STAFF REPORT
May 11, 2026

Re: **Lone Peak Retail 3 – Site Plan Request**
Application Nos.: 2026-0029-SP
Applicant: Eric Gairan of Price Real Estate, property owner
Project Location: Approximately 218 W. 12300 South
Current Zoning: CSD-LP (Lone Peak Commercial Special District) Zone
Acreage: Approximately 0.85 acres (approximately 37,026 sq. ft.)
Request: The purpose of the request is to construct two new retail/restaurant buildings with drive-thru's on a vacant lot.

EXHIBIT A DEPARTMENT REVIEWS

2 NORTH ELEVATION
A-201 1/8" = 1'-0"

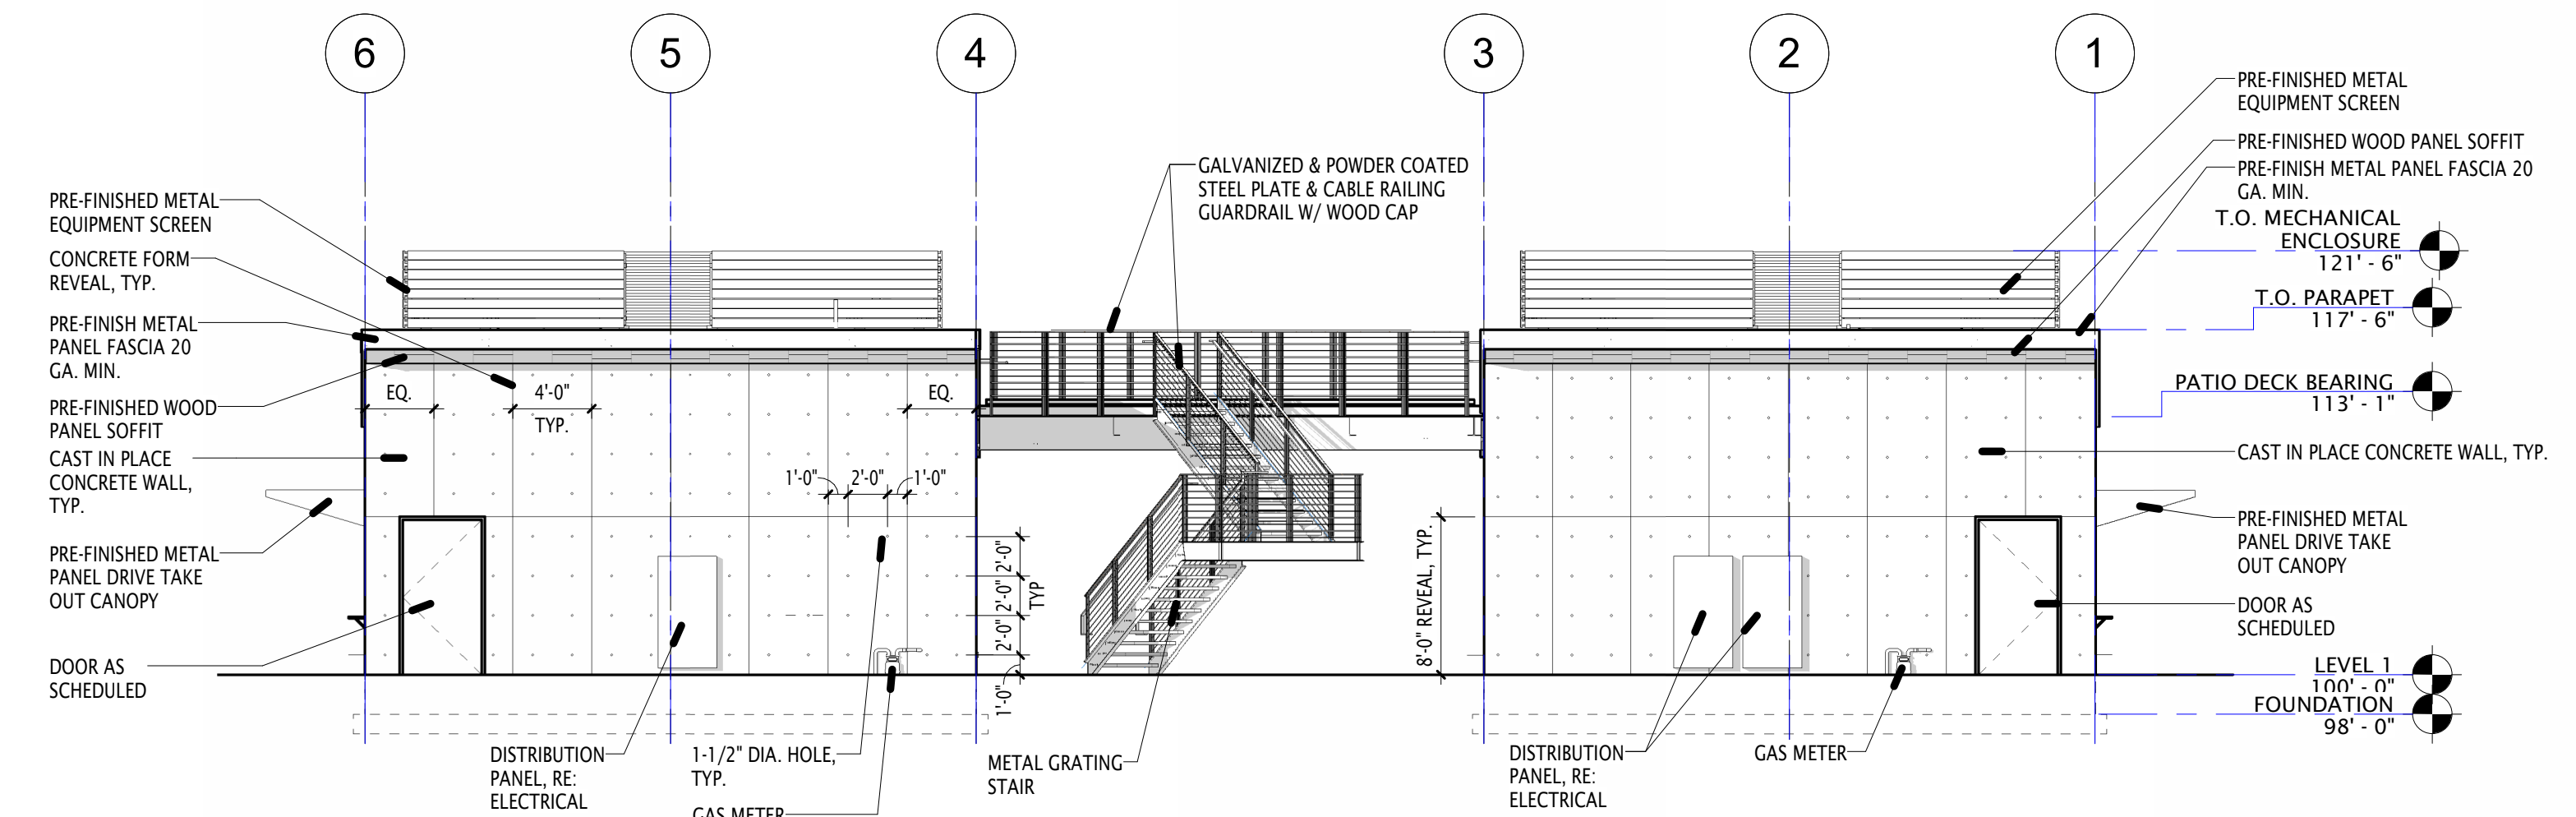
Provide a color and materials board. A digital submission is adequate.

1 SOUTH ELEVATION
A-201 1/8" = 1'-0"

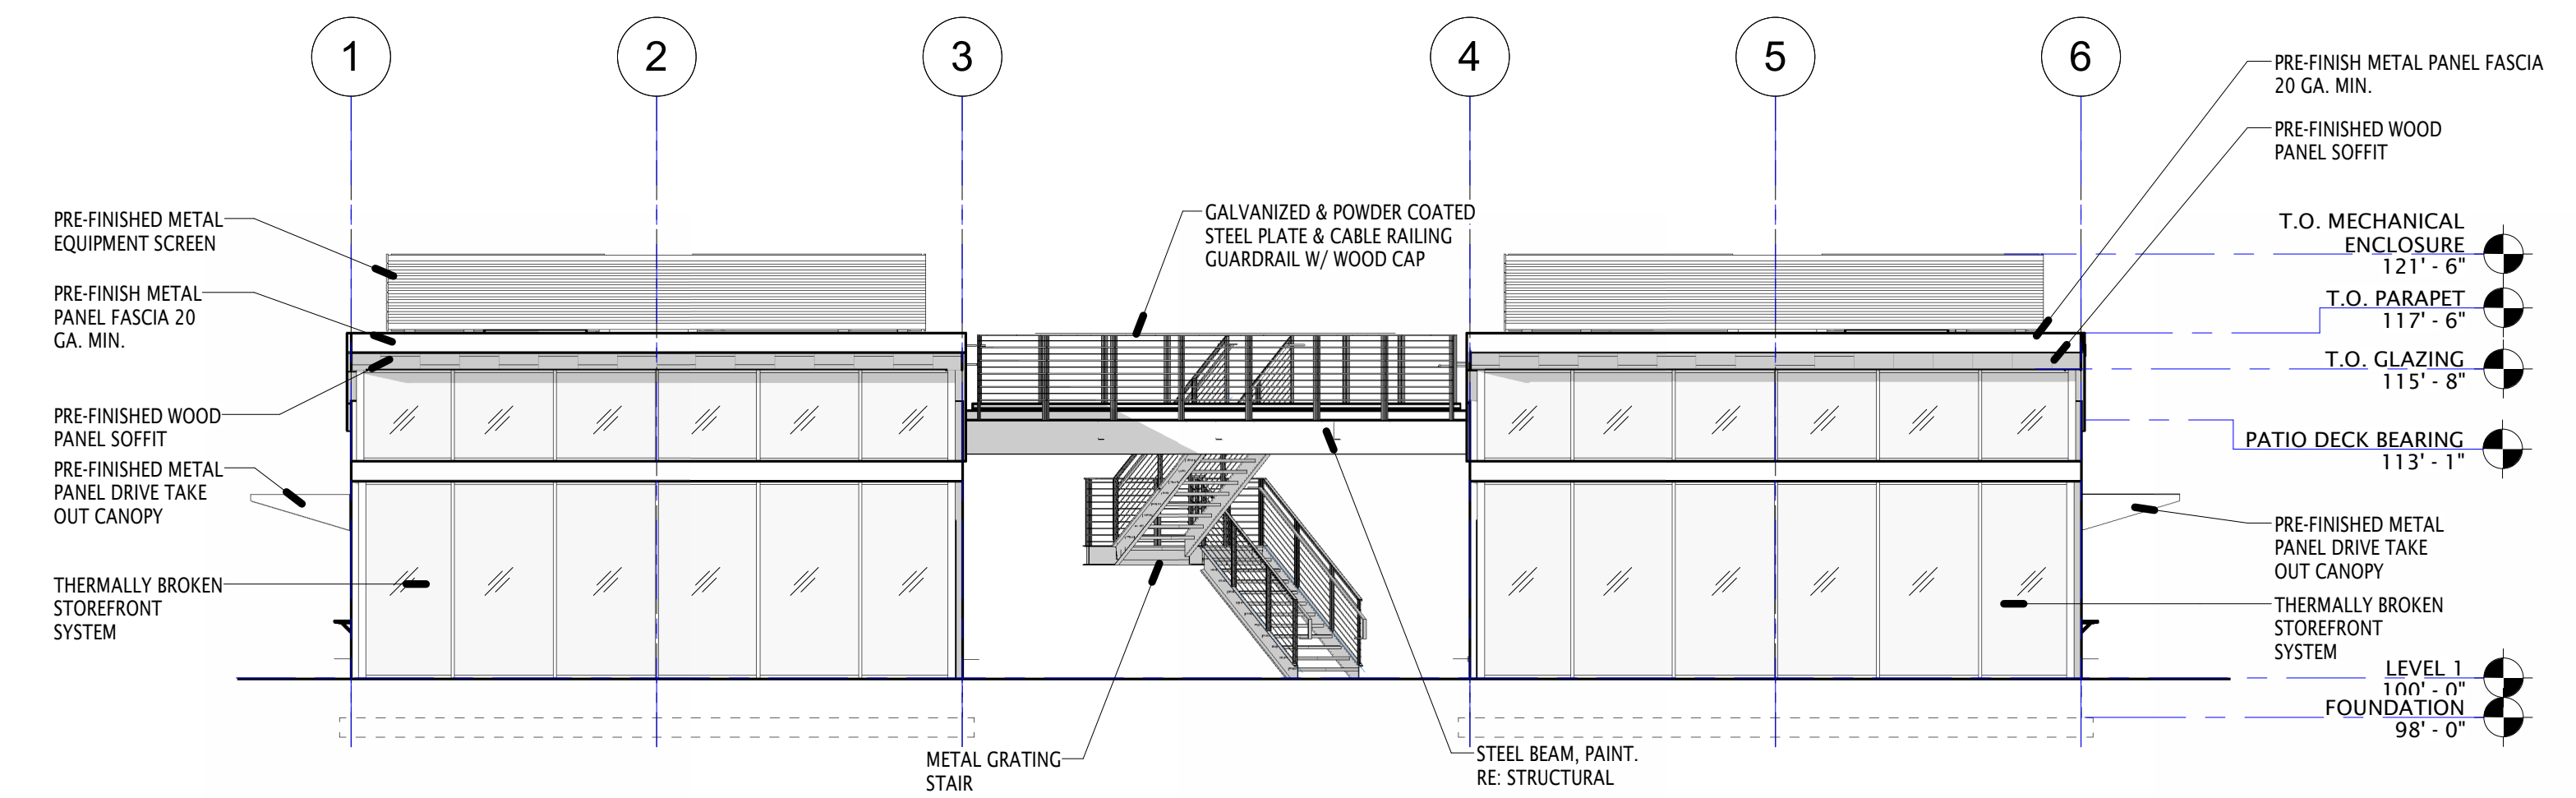
The standards in the CSD require all elevations along 12300 South to have shall have a minimum 10% element of interest as listed in 9-18G-050(1)(b). Please show how this is accomplished.
